APPLICATION NO.	FILING DATE	FIRST NAMED INVENTOR	ATTORNEY DOCKET NO.	CONFIRMATION NO.
10/509,387	09/27/2004	Pasqualino Franco	2521-1018	5048

Office Action Summary

Attachment A

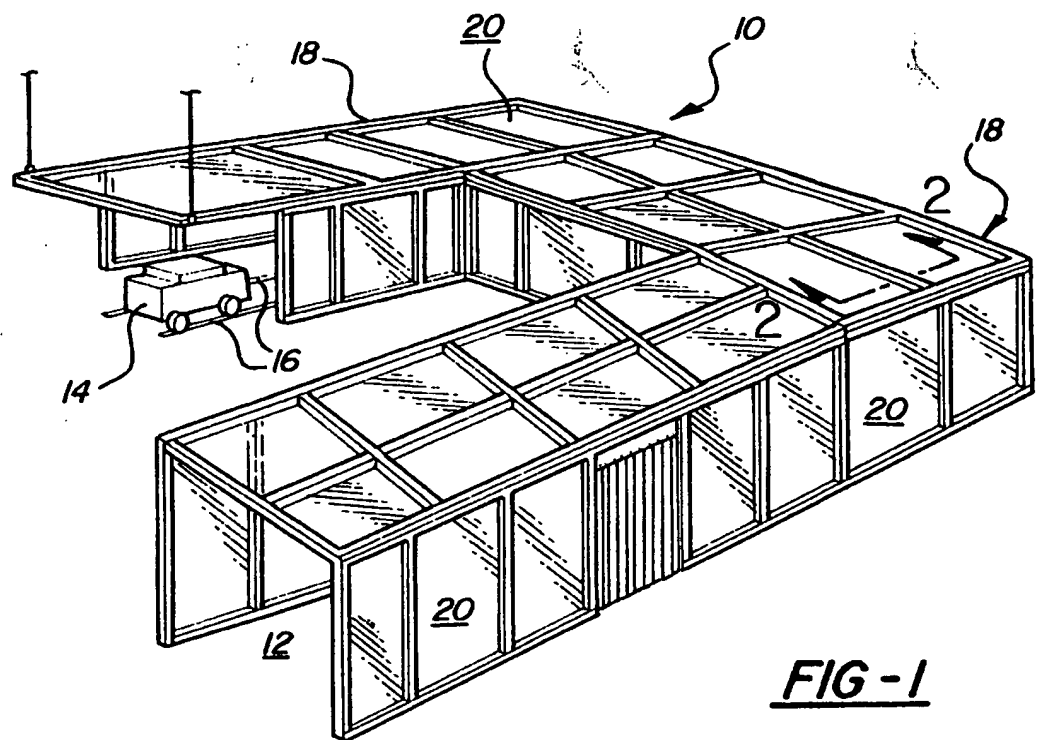
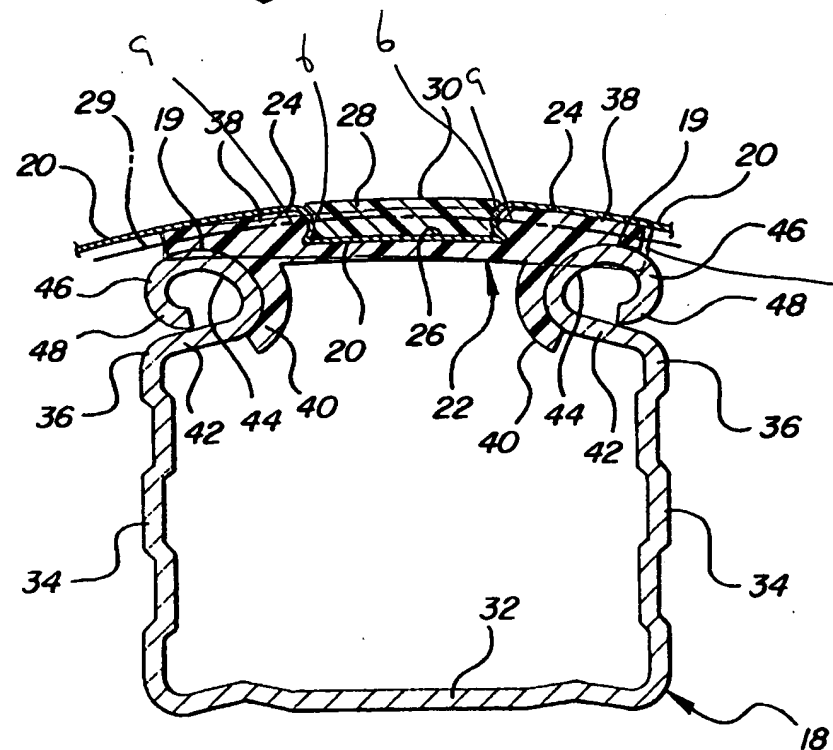
Claims 15 and 18 are rejected under 35 U.S.C. 103(a) as being unpatentable over by Lucous (4,410,027) in view of Weiss (3,229,029). Lucous teaches a flexible member attachment system (Fig. 2) comprising: a fixed element (15) having a rectangular shape (see Attachment A) with a hollow space, a "screw" hole (17) and projections (when viewing the top of the frame: the upper 25 and lower 32; the upper projection being longer than the lower one) and a mobile flat rectangular element (40; the inside end portion having a rectangular shape; see Attachment A) insertable into the inner space of the fixed element and being held in place by the projections extending into rounded notches on the mobile flat element. Note: the table, screw and cloth are not positively being claimed, the system having only to be capable of receiving a cloth (it is as shown by flexible sheet 12), having an opening capable of receiving a screw (opening receiving fastener capable of doing this) and capable of being placed on a table edge (it is because of its flat rear surface). Also, the feature description for the mobile element is open ended ("comprising"); therefore, additional members (outer members 41,43, etc. of 40) can also be part of the structure. Finally, the elements would inherently have proportional sizes relative to the window, a table inside the house, etc. For claim 15, Lucous fails to teach inner bulges on opposing sides of the hole of the fixed element. Weiss teaches the use of inner bulges (42) on the sides of a hole to help shield the fastener from other members. It would have been obvious to one having ordinary skill in the art at the time of the invention to modify the system of Lucous by

(Fig. 2) comprising: a fixed element (15) having a rectangular shape (see Attachment A) with a hollow space, a "screw" hole (17) and projections (when viewing the top of the frame: the upper 25 and lower 32; the upper projection being longer than the lower one) and a mobile flat rectangular element (40; the inside end portion having a rectangular shape; see Attachment A) insertable into the inner space of the fixed element and being held in place by the projections extending into rounded notches on the mobile flat element. For claim 24, Lucous fails to teach fixing elements on the mobile element. Bozzo teaches applying hooks and loops on a strip (20) to a structure so as to be able to attach a decorative cover (24) with mating hooks and loops (22) over the structure. It would have been obvious to one having ordinary skill in the art at the time of the invention to modify the system of Lucous by adding hooks and loops onto the outside of the mobile element, such as the strip taught by Bozzo, so that a decorative cover could be applied over the system for aesthetic reasons.

rectangular
insulation

rectangular
fixed element with
hollow space &
rectangular shape

rectangular
fixed element
w/ hollow space
& rect. shape
